**SUBDIVISION, PLANNED UNIT
DEVELOPMENT & SIDEWALK WAIVER
REQUEST STAFF REPORT****Date: March 7, 2013**

NAME I-65 East Service Road Development Subdivision,
Resubdivision of Lot 1

CONTEMPLATED USE *Subdivision* approval to create two legal lots of record,
Planned Unit Development approval to allow multiple
buildings on a single building site and *Sidewalk Waiver*
approval to waive construction of sidewalks along East I-65
Service Road South.

SITE PLAN

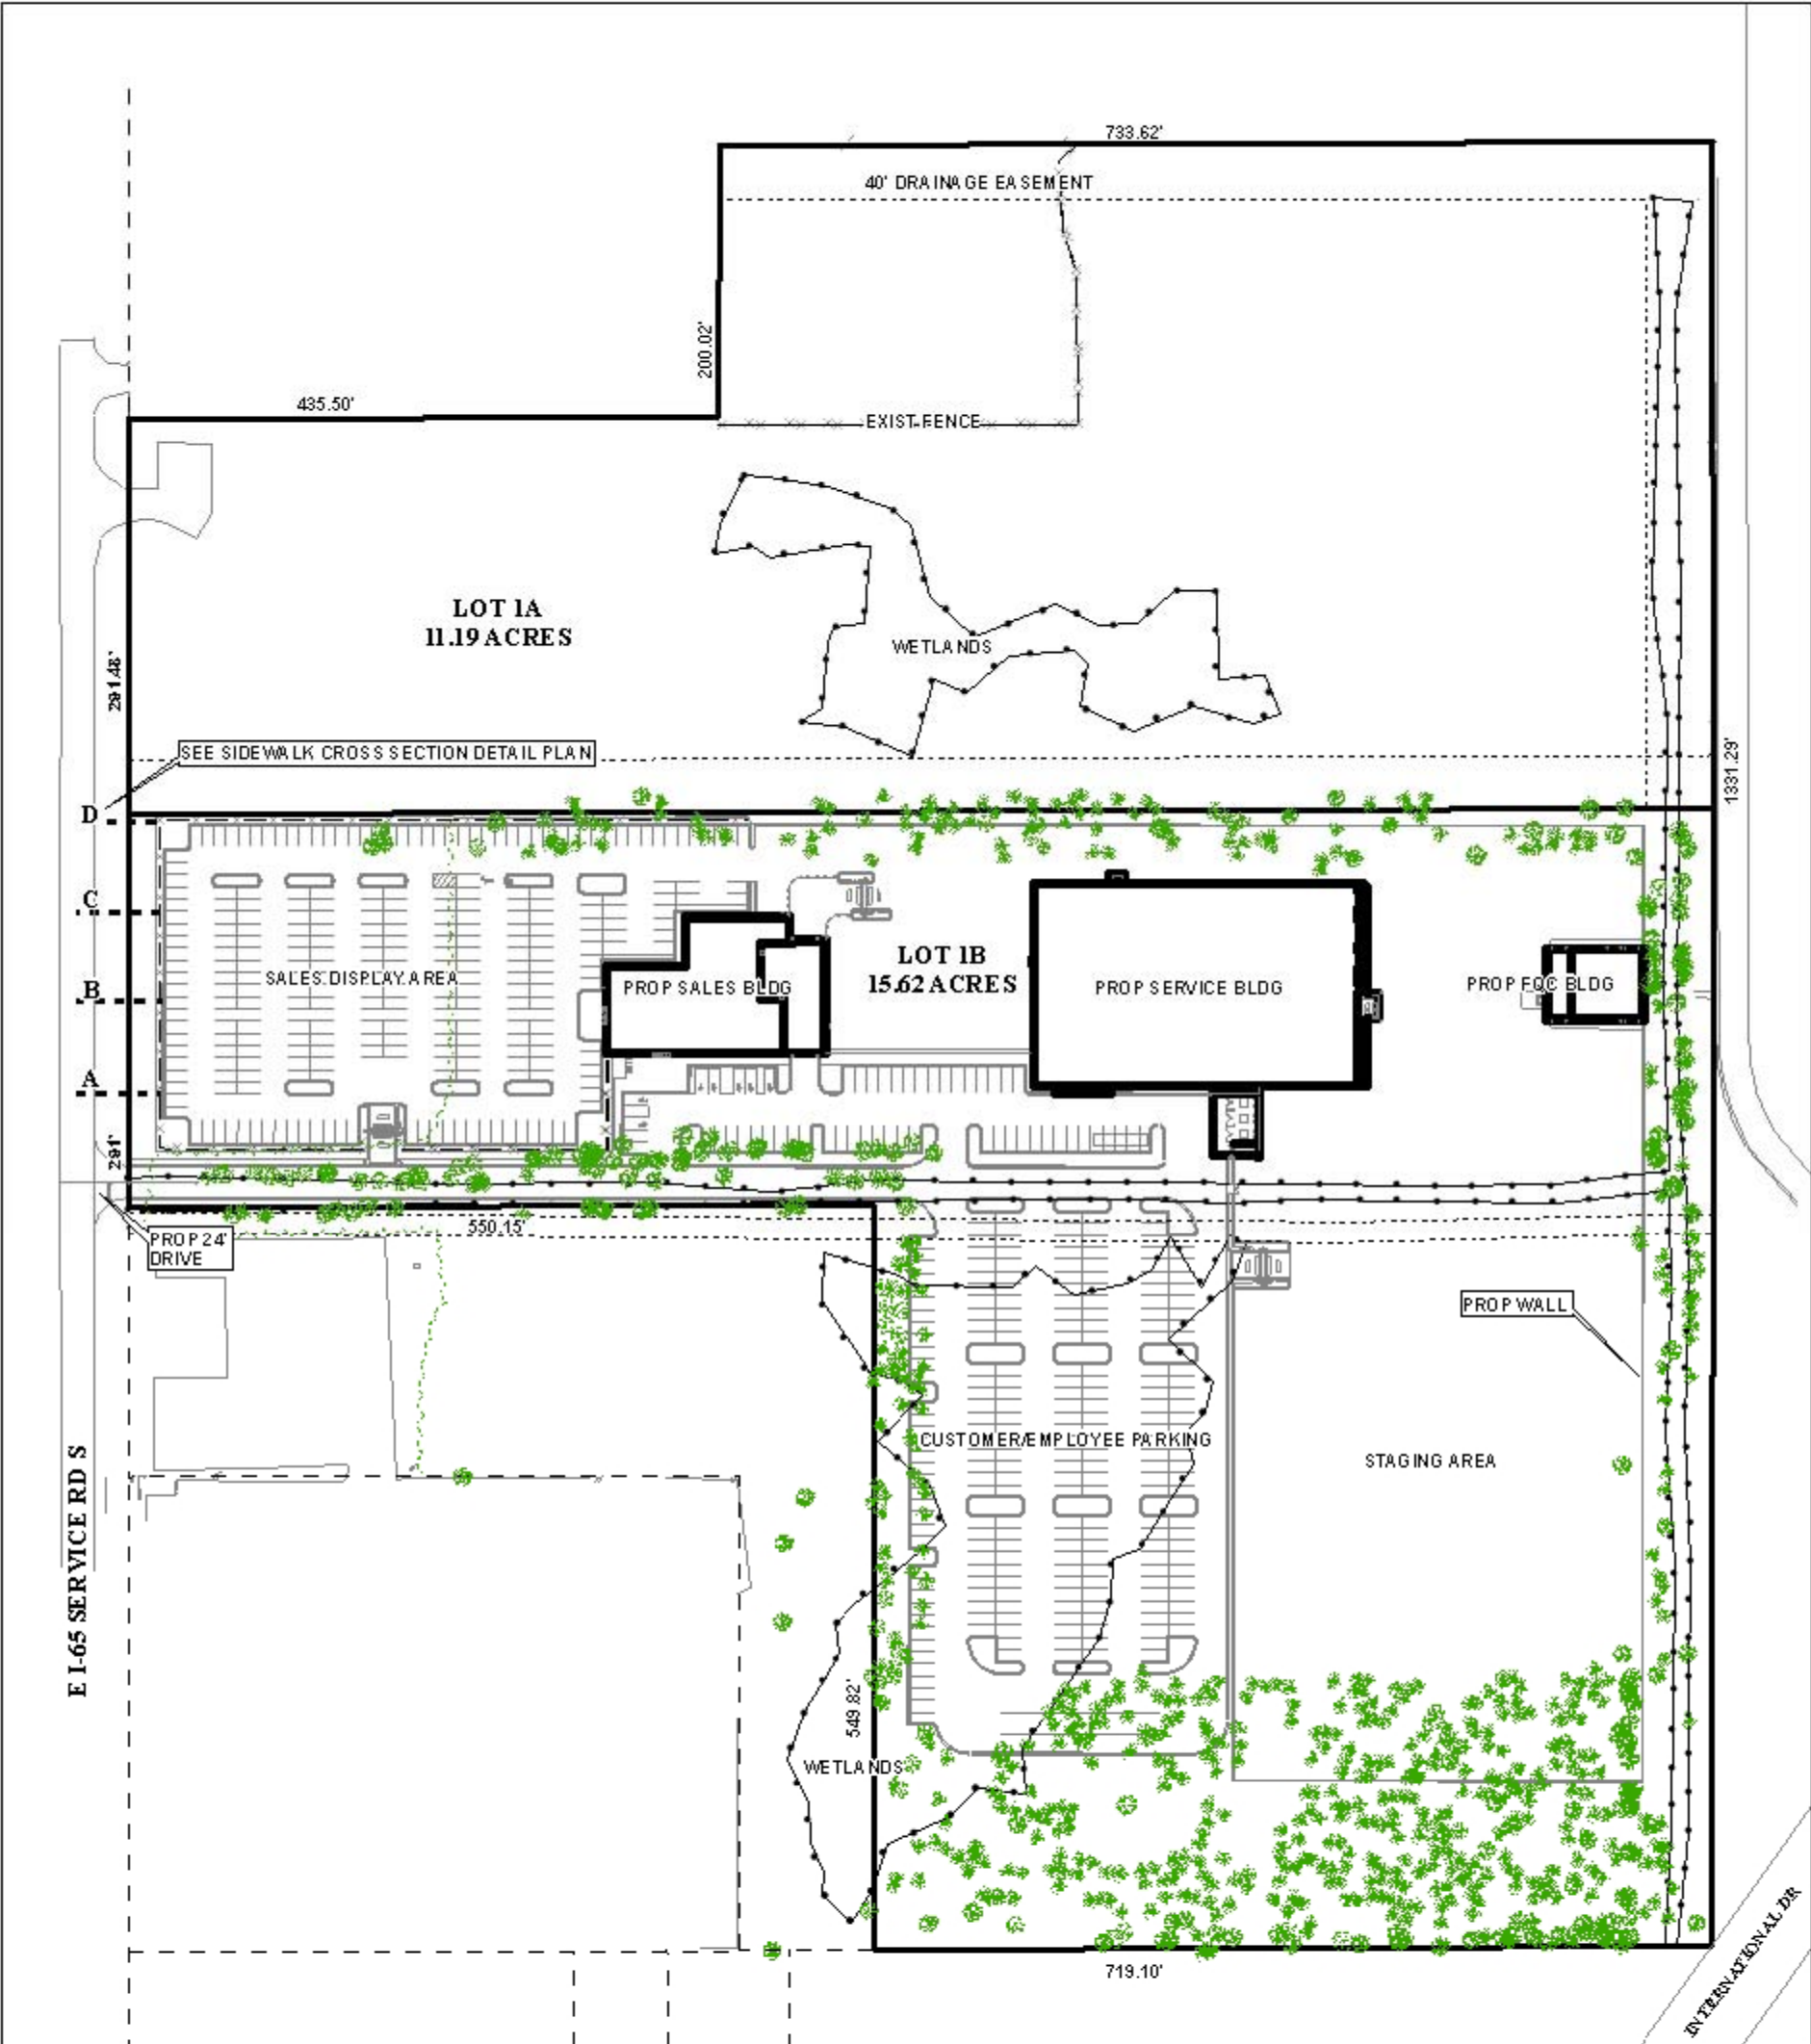
The 25-foot minimum building setback line is depicted on the preliminary plat along East I-65 Service Road South; and should be retained on the Final Plat. The Final Plat should retain the labeling of the lots with its size in square feet/acres, or placement of a table on the plat with the same information.

Much of the Subdivision site appears to contain wetlands, as identified by available National Wetlands Inventory data, and some wetland areas are delineated on the PUD site plan, but not on the Subdivision plat: wetlands should be delineated on both the site plan and the plat. The potential presence of wetlands indicate that the area may be environmentally sensitive; therefore, the approval of all applicable federal, state and local agencies would be required prior to the issuance of any permits or land disturbance activities.

Also illustrated on the preliminary plat are several easements; therefore, prior to signing of the Final Plat all easements vacated/active should be illustrated on the Final Plat and the site plan.

As depicted on the proposed PUD site plan are three buildings a 12,873 square-foot sales area, a 36,320 square feet service area building, a non-public carwash building, 289 proposed spaces for

Dumpster location(s) for the site are depicted on the site plan seem to comply with Chapter 64-4.D.9. of the Zoning Ordinance; therefore, the applicant should provide a detail drawing to be submitted when permitting for and place a note on the site plan stating that dumpsters will be completely screened from view and tied to sanitary sewer.

One issue that could be considered critical to the development of the site is the percentage of frontage landscaping. The applicant illustrates landscaping of the proposed site; however, the plan does not comply with the frontage landscaping regulations. Therefore, if approved, compliance with the landscaping percentages and tree planting requirements of the Zoning Ordinance should be required. The site is 15.6± acres; therefore, 12 percent (81,648 square feet) of the **total** site must be landscaped, of this 12 percent, 60 percent (48,989 square feet) of the landscaping must be located between the building and the right-of-way. On many commercial developments, this could be an issue; however, considering the shape of the site the PUD can make allowances. This site may be one of the sites that allowance may be made. Due to such a large lot, the site only provides approximately 291 linear feet of road frontage along East I-65 Service Road South, a significant amount of frontage on a private road within Colonial Bel Air Mall. Therefore, for calculations pertaining to the frontage requirements for the approval of the Planned Unit Development, the frontage landscaping between the private road and the carwash building should be included in the frontage landscaping calculations.

- 1) retention of the lot sizes in both square feet and acres on the site plan, or the furnishing of a table on the site plan providing the same information;

- 2) revision of the site plan to provide the front and total landscaping square footage in percentages as illustrated on the Planned Unit Development application;

- 3) revision of the site plan to provide dumpster buffering, in compliance with Section 64-4.D.9. of the Zoning Ordinance, and tied to sanitary sewer;

- 4) labeling of any required detention area as common area and the placement of a note on the site plan stating that the maintenance of the common area is the responsibility of the property owners;

DETAIL SITE PLAN

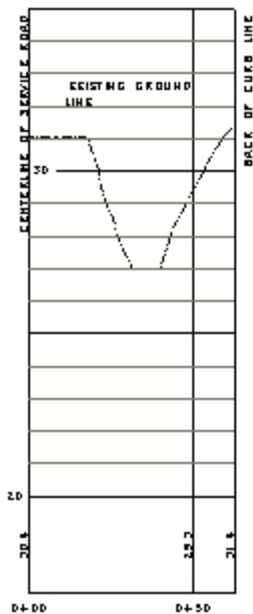
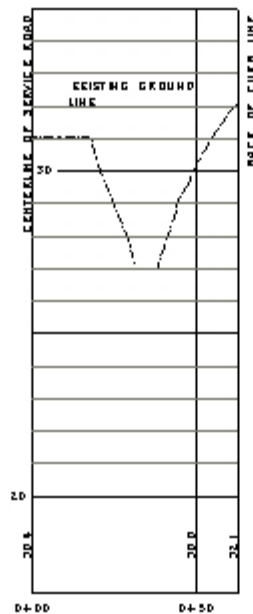
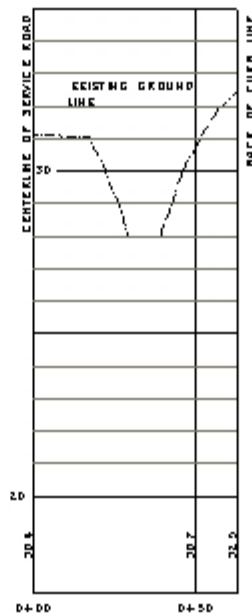
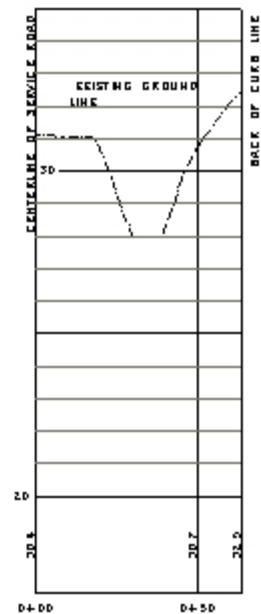
Sidewalk Waiver: Due to the existing site conditions, existing drainage ditches, limited usable land adjacent to the existing I-65 Service Road it is recommended that this request be approved.

Regarding the Sidewalk Waiver request, the applicant states the sidewalk would be located adjacent to an open ditch, which would be dangerous for pedestrians.

Not having sidewalks on East I-65 Service Road South does not negate the fact that a sidewalk is required by the Subdivision Regulations. It should be noted that an analysis of GIS shows that there are no sidewalks in the vicinity of the site and that between May 1995 to present date two sidewalk waiver applications have been applied for and approved in the vicinity of this site.

Sidewalk Waiver: Based on the preceding, it is recommended that this application be approved.
